THE ILLUSION OF ENVIRONMENTAL PROTECTION

PERMITTING LONGWALL COAL MINES IN PENNSYLVANIA

Schmid & Company, Inc., Consulting Ecologists

This report provides an in-depth, independent review of the Foundation Mine permit application and its review by the CDMO. This analysis provides a unique insight into the current regulatory review process involving longwall coal mines in Pennsylvania. It examines how well the current review process implements the laws and regulations adopted to protect environmental resources from coal extraction activities. This report uses the Foundation Mine application as a case study to determine how successfully the Pennsylvania Department of Environmental Protection requires an applicant to inventory resources at risk from a proposed longwall mine operation, predict potential impacts, and identify measures to minimize and address likely impacts in accordance with existing laws and regulatory requirements. The report also examines the adequacy and effectiveness of the State's mine permit application forms, technical guidance, and overall process in eliciting the information necessary to evaluate potential impacts and to demonstrate compliance with applicabl

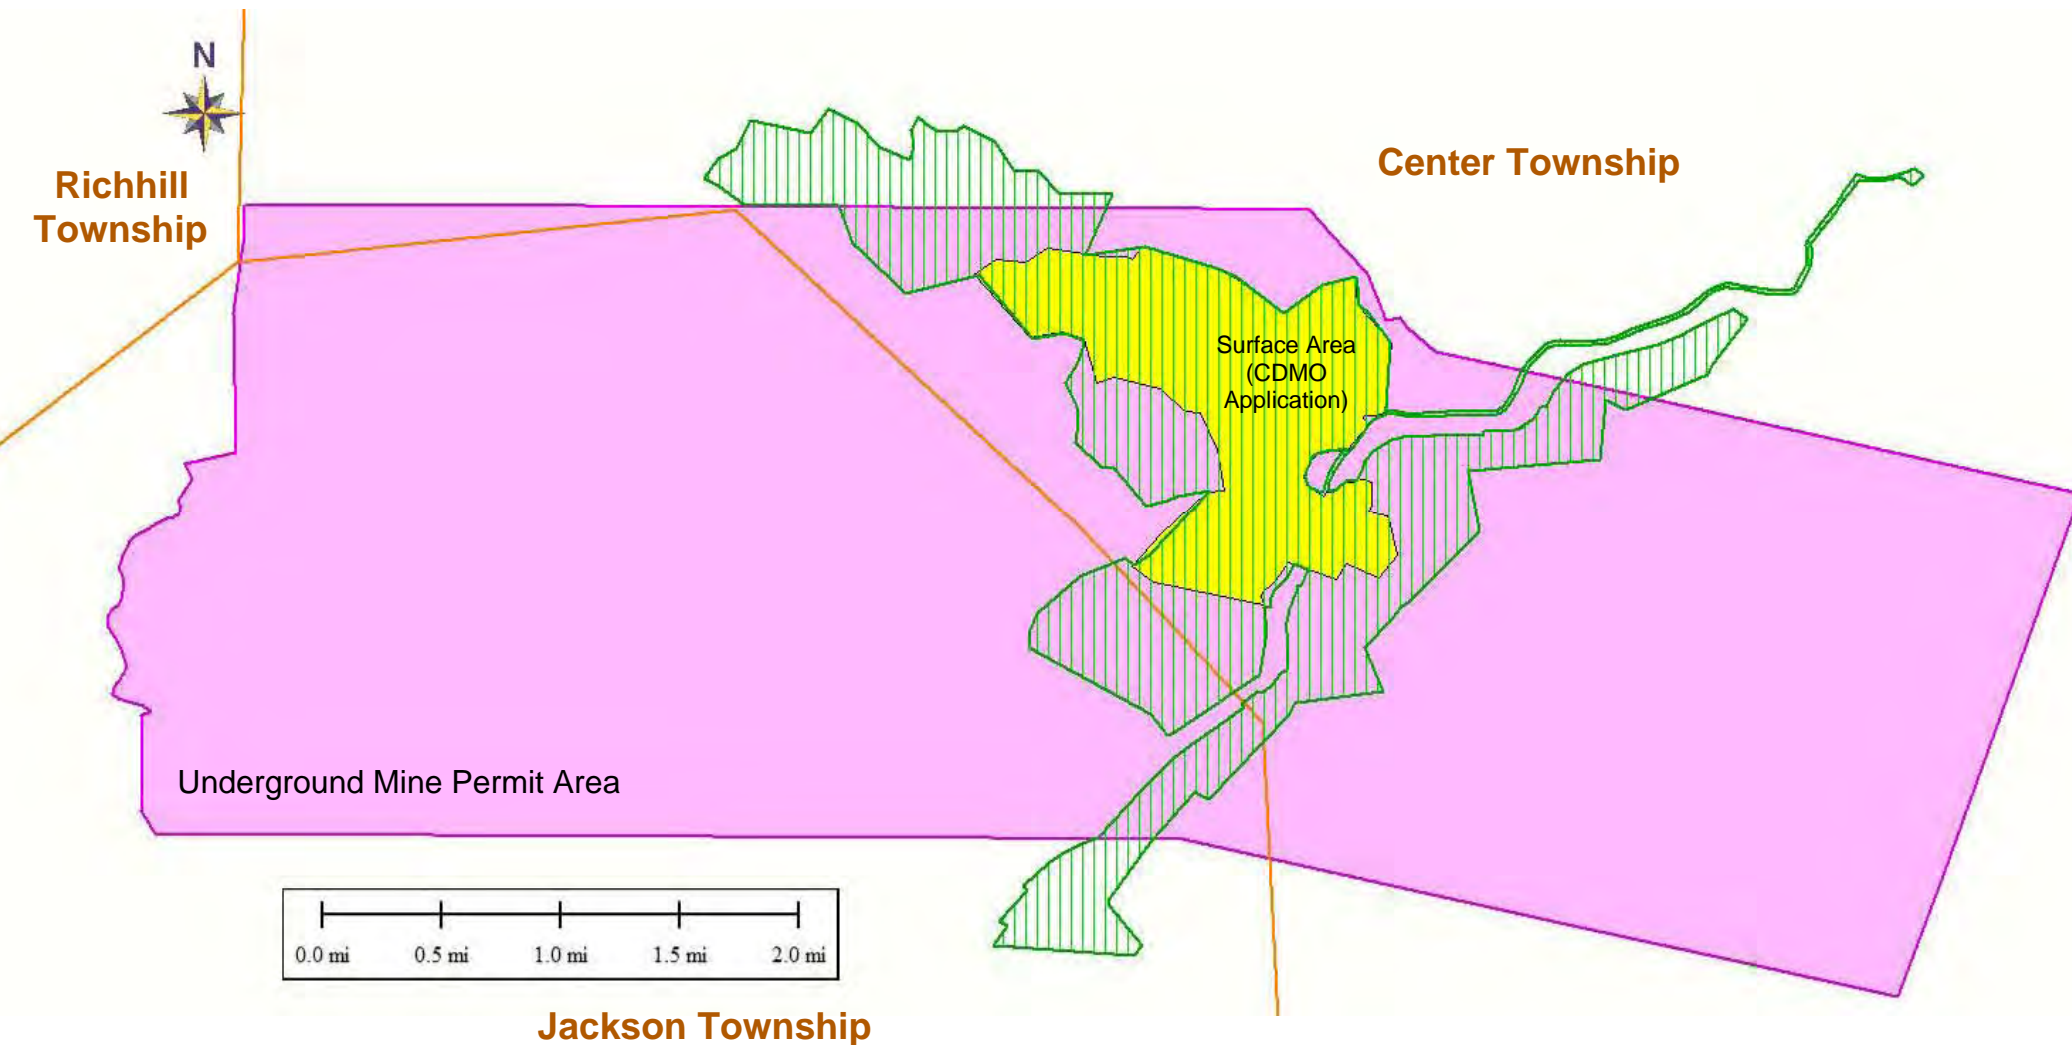
Given the high probability of damage to its industrial facilities by subsidence, longwall extraction generally is not conducted beneath a mine's surface facilities. The layout of longwall panels presumably would need to be revised significantly from what was proposed in the 2010 State mine application if the additional surface activities on 1,225 acres were to be constructed as proposed in the 404 permit application.

According to Module 15 in the State underground mine permit application, the activities proposed in State and federal applications must be consistent. Form 15A (in Module 15) states that *"If the scope of activities described under the federal permit application differs from the scope of activities described under the state permit application, attach a copy of the federal permit application"*. The (undated) Form 15A for Foundation Mine noted that a Corps Individual Permit was "pending", although that Corps 404 application apparently was not *submitted* until more than a year after the 2010 State mine application was submitted. Form 15A states that any substantial

revisions per a federal application must be provided to the District Mining Office. No copy of the federal permit application was found in the CDMO files provided during our November 2011 or March 2013 file reviews. Reportedly, the applicant did provide a complete copy of the Corps 404 application to the CDMO, but the CDMO promptly *returned* it, explaining that it was of no interest to the State's reviewers.

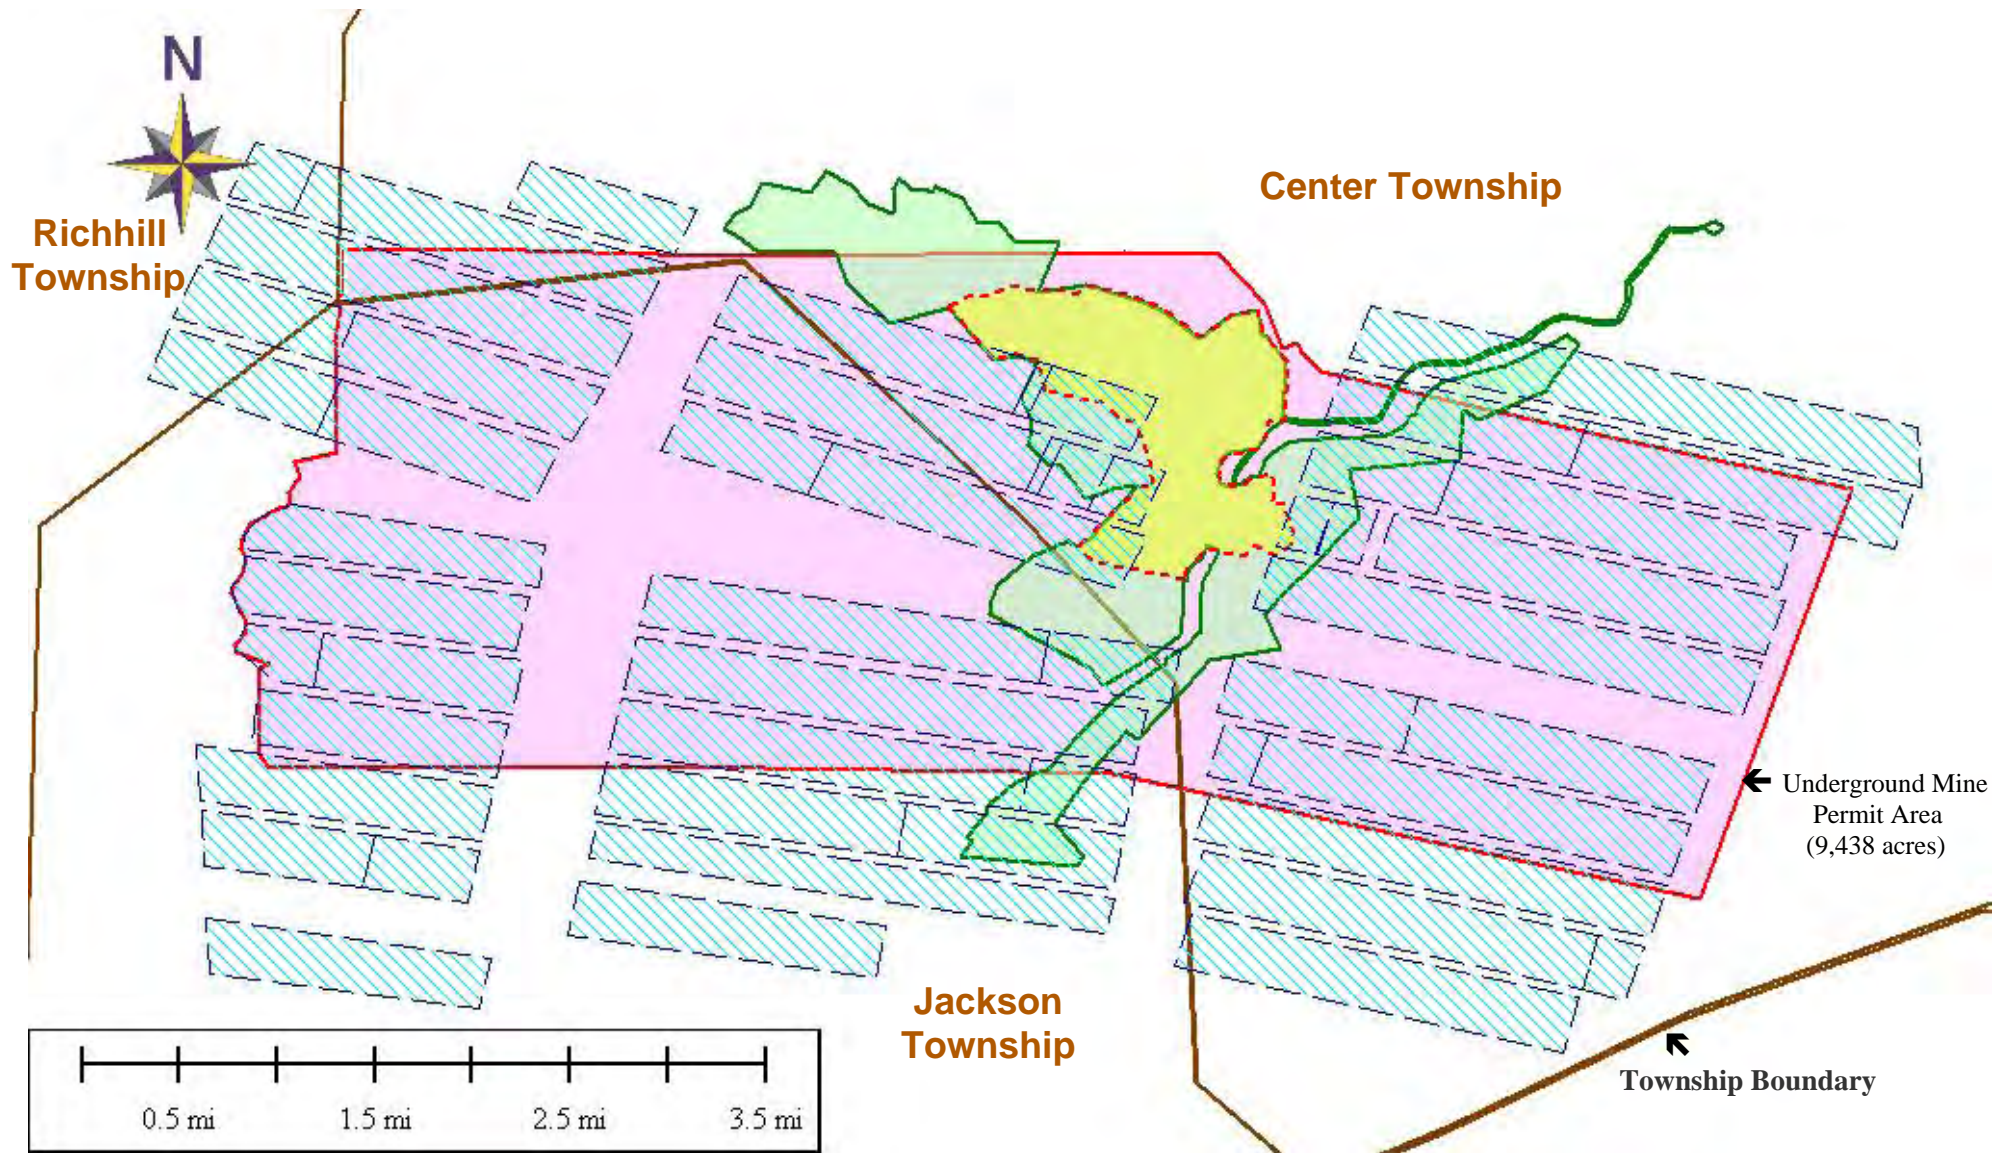
A close examination of some of the maps in both the State underground mine application and the federal 404 application identified proposed mining that extended far outside the 9,438-acre area (**Figure 4**). Some maps identified areas designated for future mining (e.g., “Years 21 to 25” on Drawing 22.4). It is unacceptable that an application for a new mine did not clearly identify the maximum ultimate extent of the proposed operation (relative to unmined resources or the applicant’s mineral holdings), even if all of the specific details of future expansions were not known at the outset. Without full disclosure of what was to be done and where, and over what period of time, the reviewing agencies (much less members of the public who will be directly and indirectly affected) cannot not understand the project well enough to make an informed decision regarding its relative benefits and impacts.

for any contiguous coal tracts or surface lands in the future. This statement was inconsistent with certain application drawings which showed longwall panels extending well beyond the “proposed” underground permit boundary (see **Figure 4**), and/or identified time periods beyond the proposed 20 years (e.g., drawings in Module 22 [22.4-3-10, Panel 29-2-1] showed areas to be mined in “Years 21-25”). It also contradicted information provided in a recent Commonwealth Court case⁵, which noted that:

Recommendation: The exact full extent of any proposed underground mine, as well as the approximate extent and number of its potential future expansions, must be made clear.

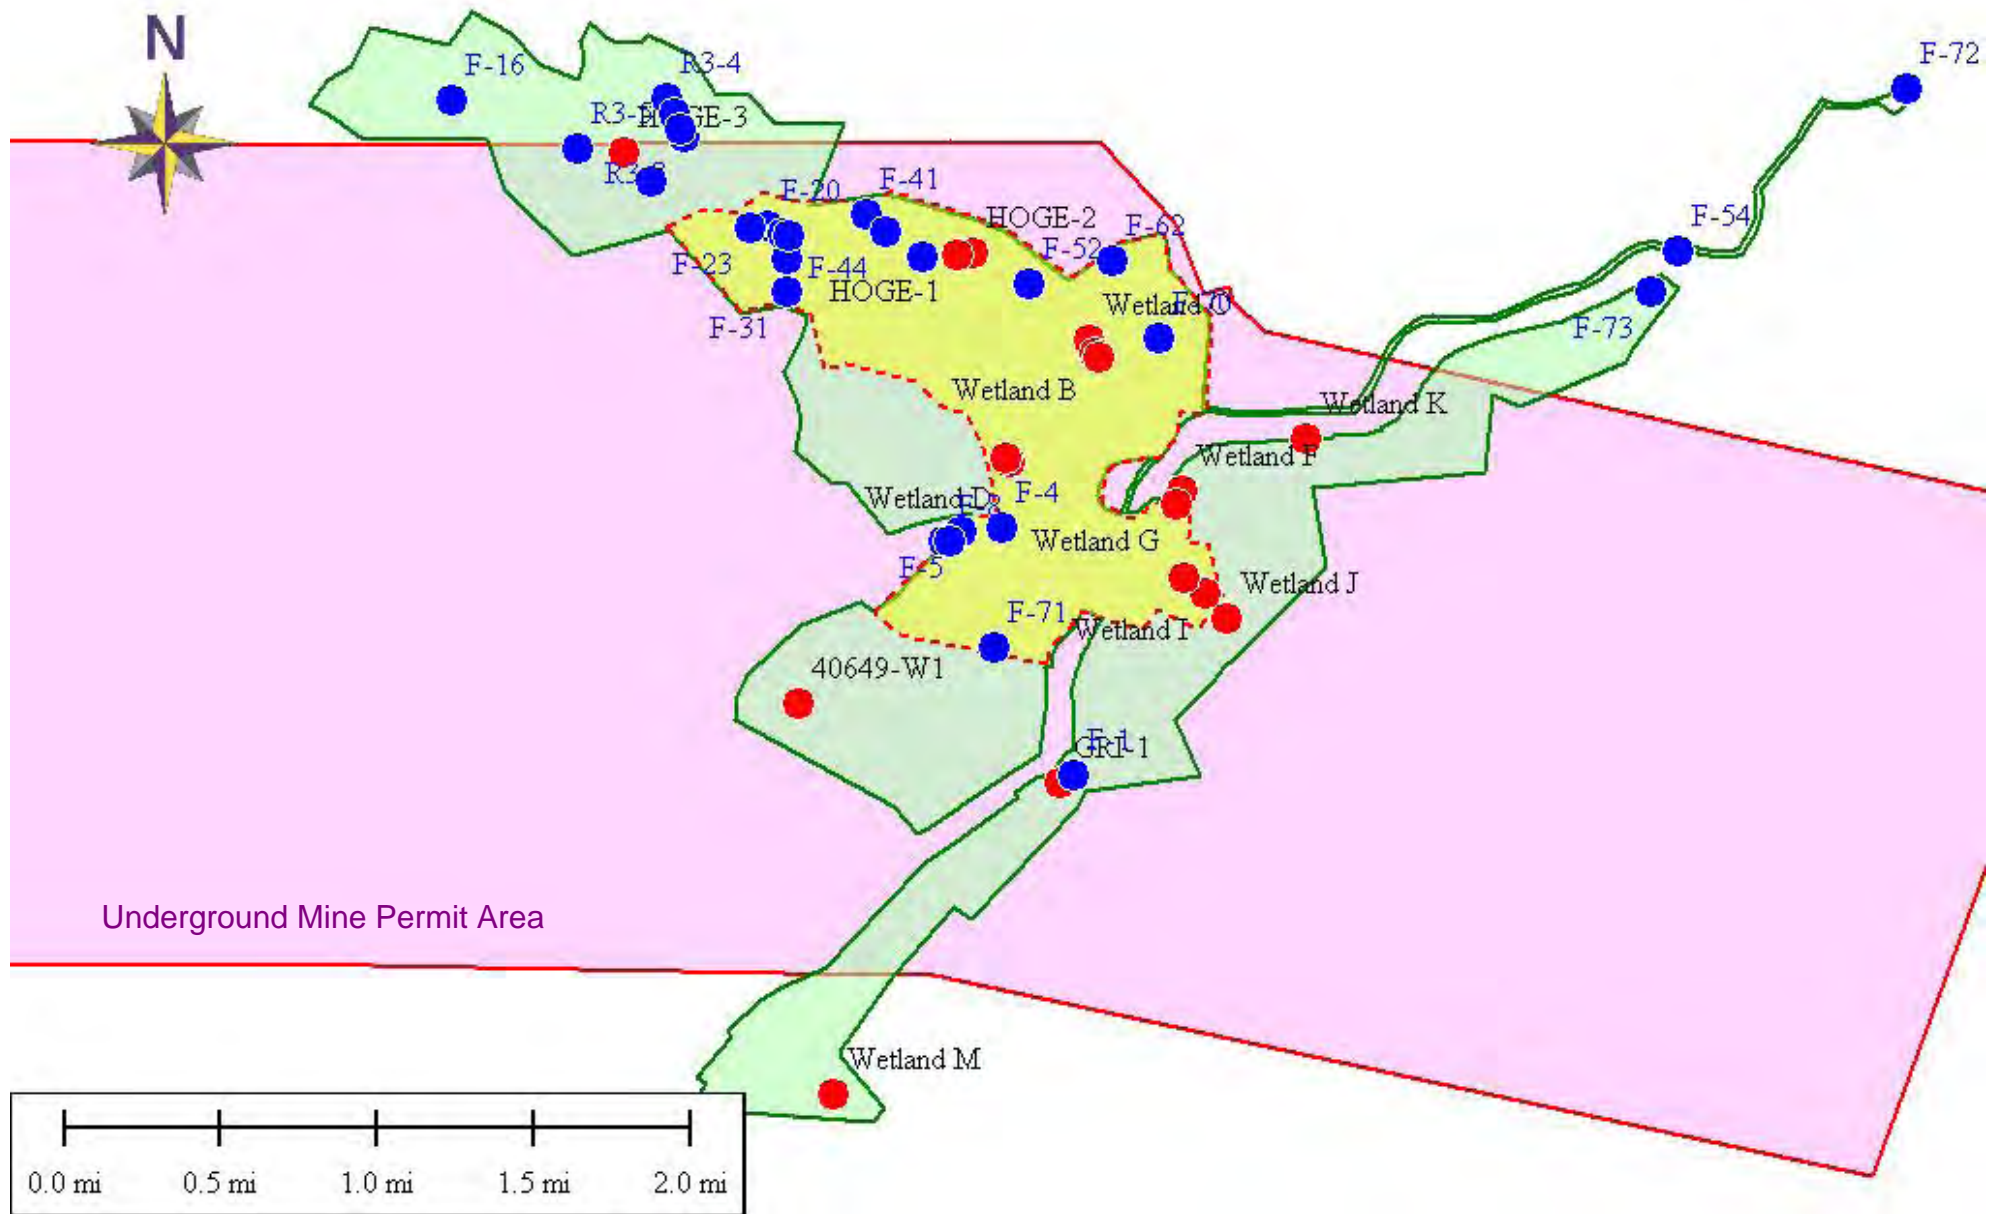
The 28 additional wetlands identified by the Corps but not by the applicant within the 1,867-acre area represent more than half of the final total of 44 wetlands there (**Figure 5**). Such a discrepancy clearly illustrates the necessity and importance of having a Corps JD performed in conjunction with every coal mine application if all wetlands are to be identified.

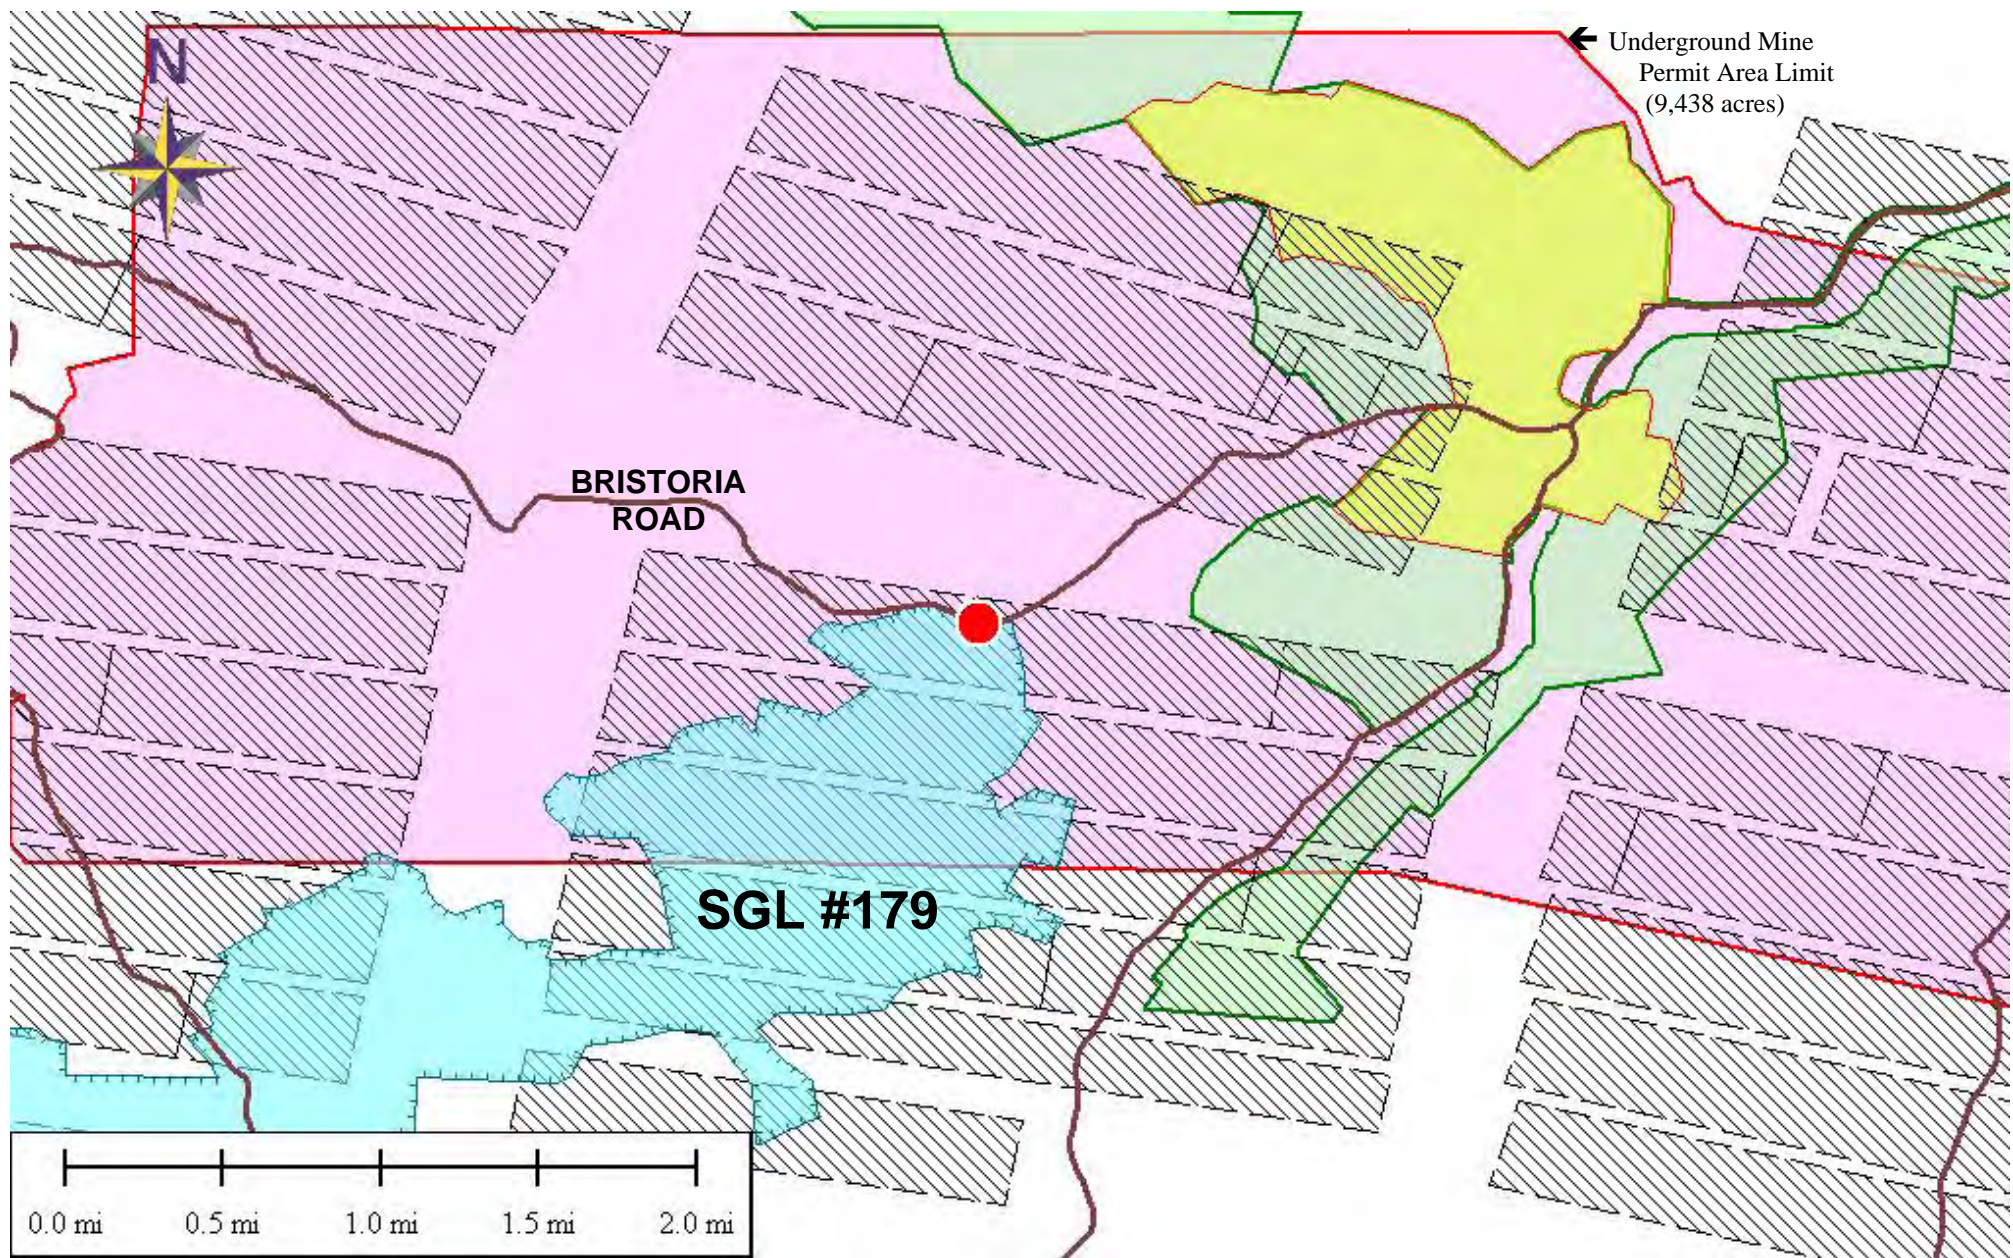
of Foundation Mine outside of the surface activities area. Numerous additional wetlands were observed (see **Figure 7**), wetlands that were not delineated in this permit application or reviewed/confirmed by Corps JD. One wetland of significant size (approximately 5 acres) was observed along the south side of Bristoria Road, within State Game Lands #179 (see **Figures 6a** and **6b**).
